RAINIER SQUARE REDEVELOPMENT RECOMMENDATION MEETING

Design Review Submittal # 2

Address: 1301 5th Ave., Seattle, WA 98101

DRB #2 Review Date: June 23, 2015

B.4 / C.2 Northwest Carve / Fourth Avenue Update

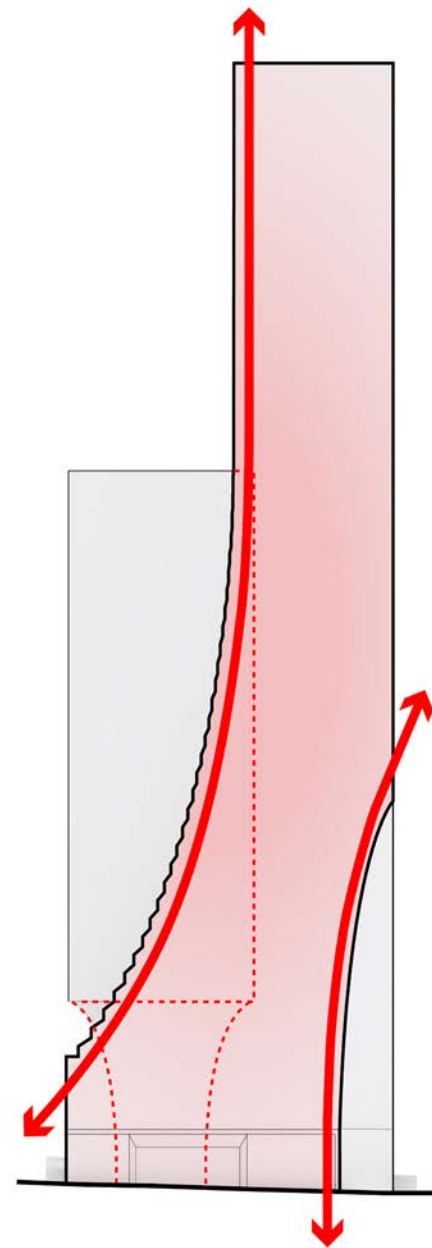
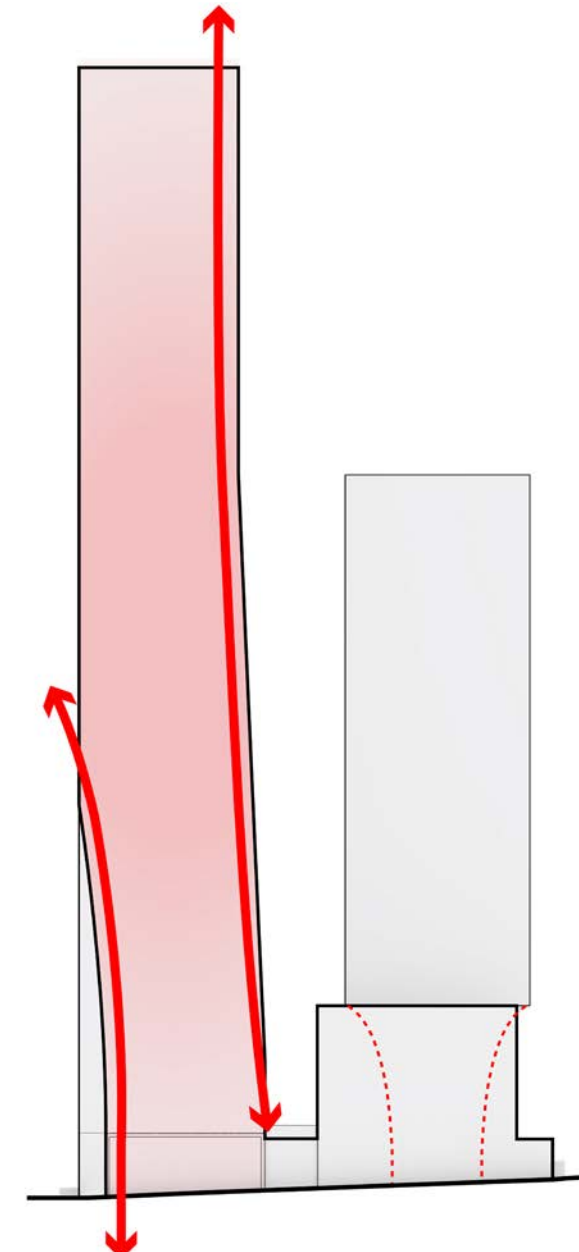
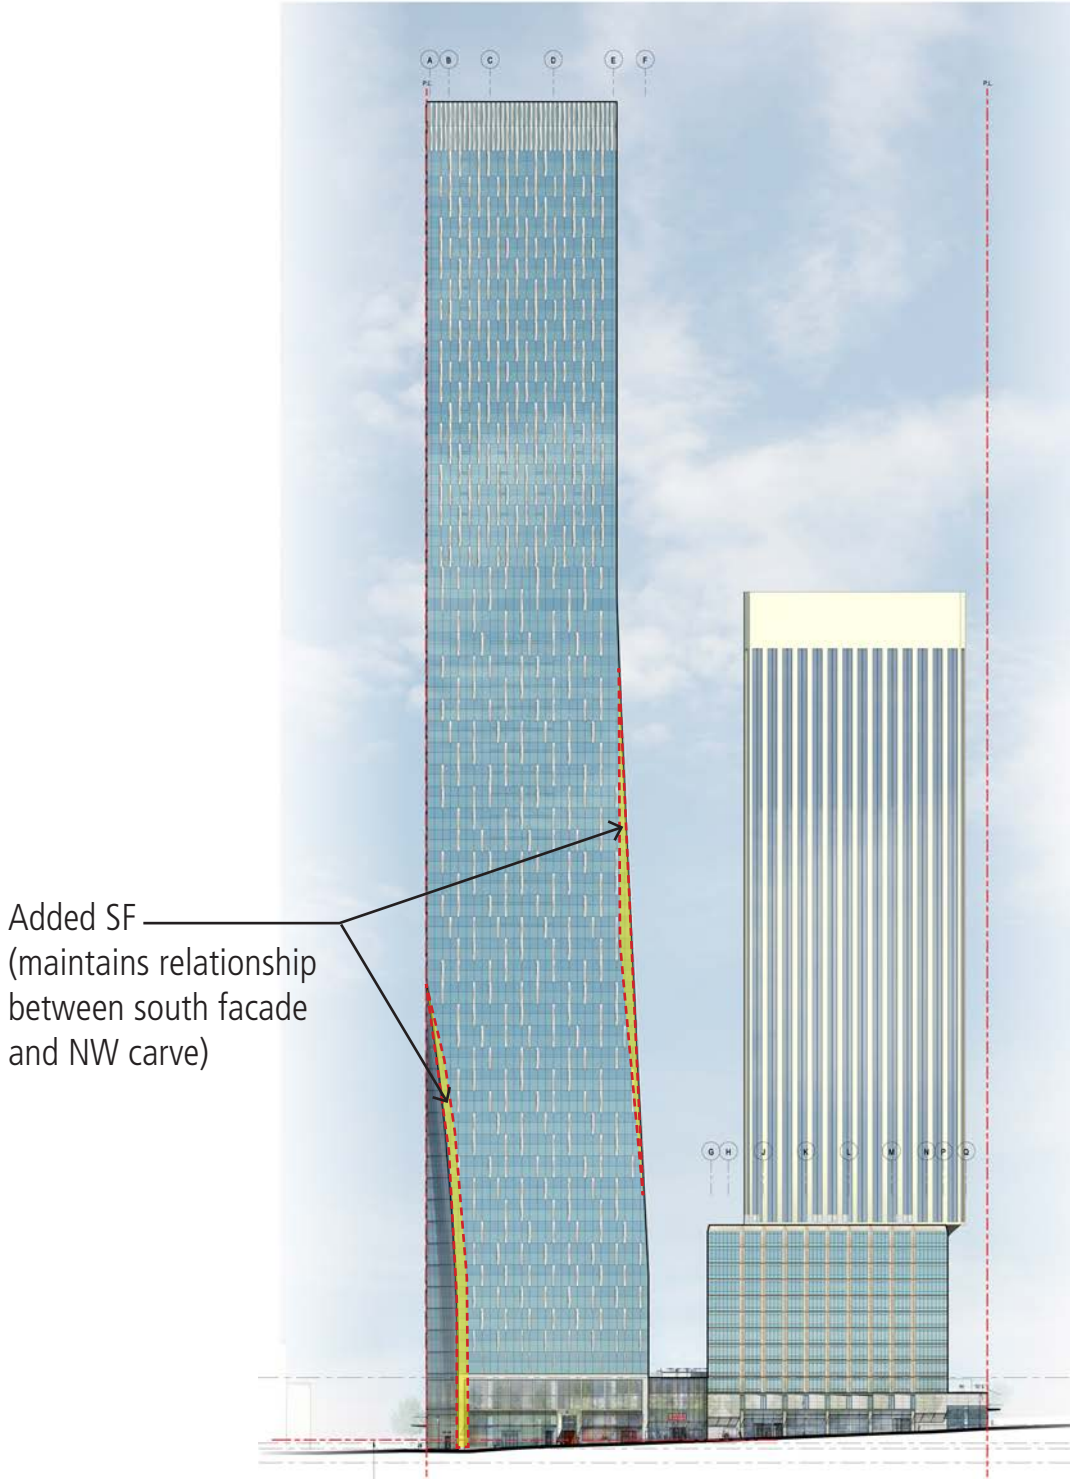
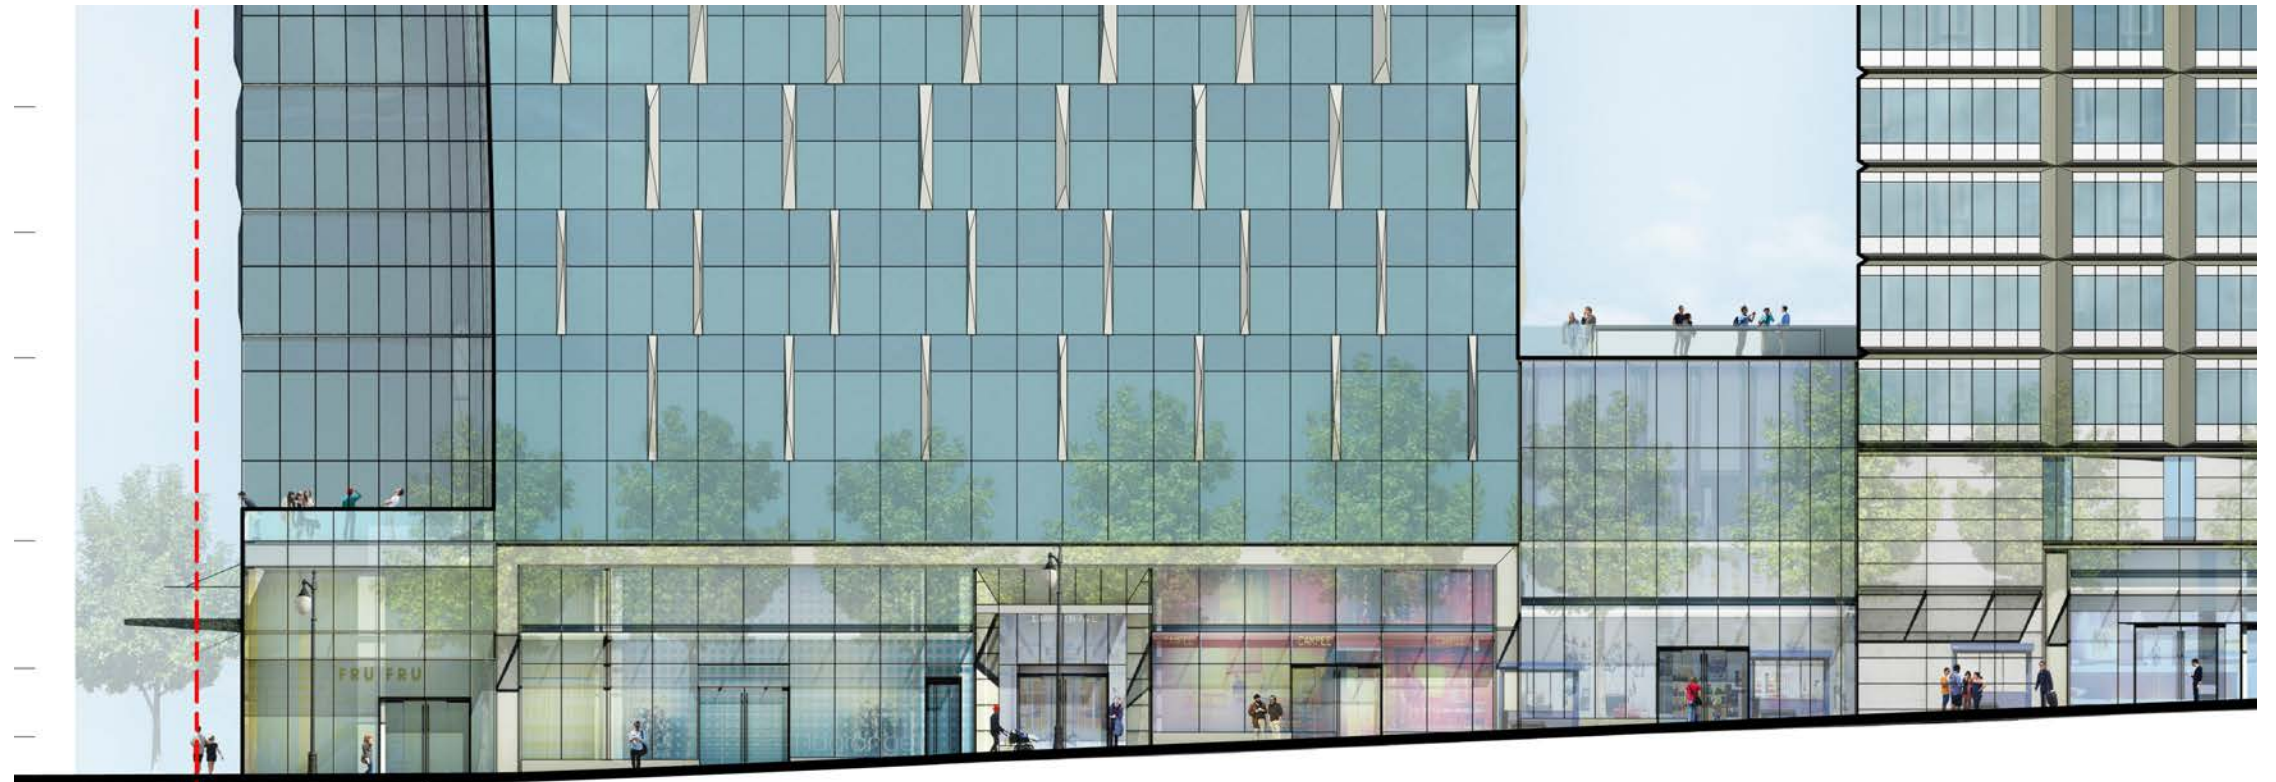
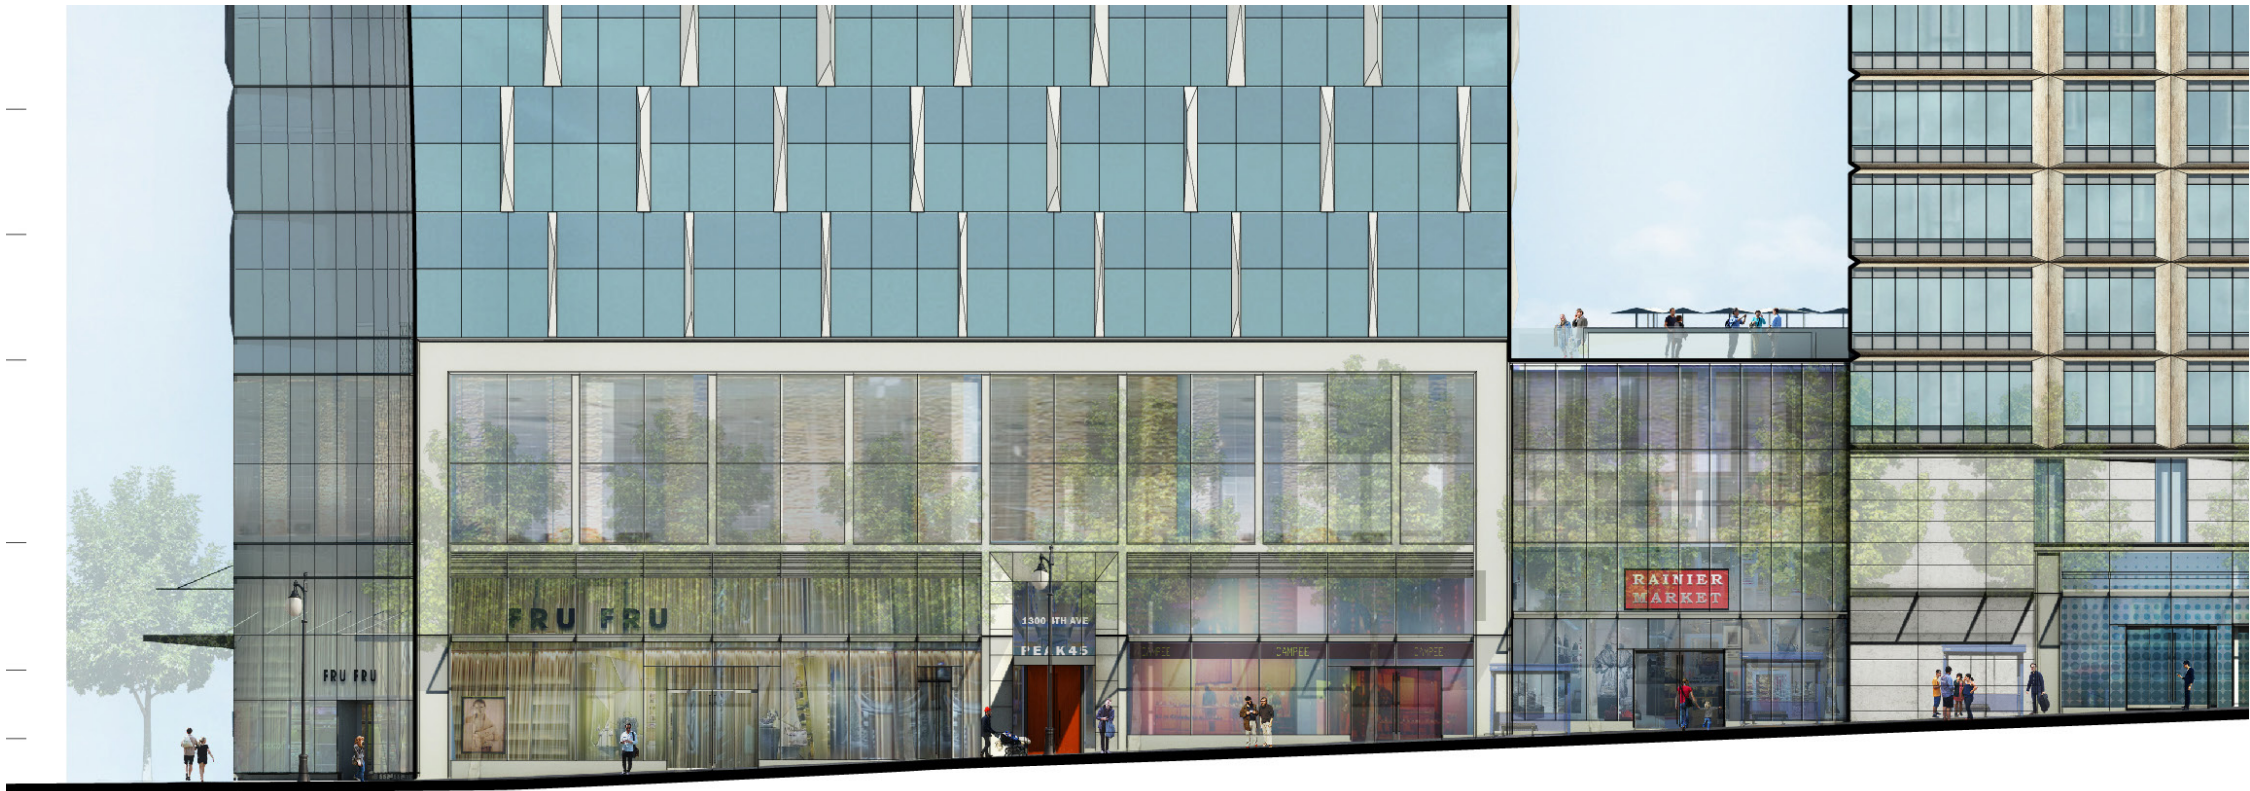
B-4 Guidance, Recommendation Meeting: The two-story base, composed of storefront glazing, stone at the entries and a grey metal band at its cornice, loses its presence along the Fourth Ave. elevation due to its lower height. The Board directed the applicant to revise the lower façade to achieve a two-story base similar to the Union St. and Fifth Ave. elevations.

C-2 Guidance, Recommendation Meeting: The long vertical scoop forming the proposed tower's northwest corner needs to extend to grade. This will heighten its visual drama and create a modest open space or entry plaza at a significant corner. The Board added that this scoop could be eliminated if the revised geometry of the major swoop facing Fifth Ave was found to be satisfactory.

- C-2 Guidance: The scoop at the northwest corner has been extended to grade as requested by the Board. See page 26-27 for proposed ground plane development at new pedestrian plaza area.
- B-4 Guidance: The lower façade has been revised as requested by the Board to achieve better alignment along 4th Avenue, Union Street, and 5th Avenue elevations.
- Massing has been adjusted slightly at the upper levels of the office tower to maintain the relationship between the south façade and the revised northwest carve.
